TECHNICAL BULLETIN

[Issue No.] T99-0035

[Title] Production discontinuation of MELSEC-A series model [Relevant Models] A1SY42

5. A1SY42P/A1SY42 internal circuit diagrams

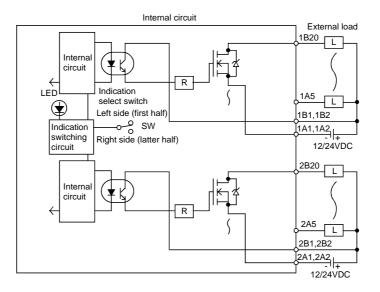
4. Specifications comparison between A1SY42P and A1SY42

^{*1:} The fuse that was included in the A1SY42 was limited to only protecting the wiring between the A1SY42 and the external device from burning out when a short occurred in the external device. However, this did not protect internal components in the A1SY42, such as transistors, capacitors, etc., from being destroyed. Also, the internal fuse did not protect against other faults caused to the A1SY42 internal components.
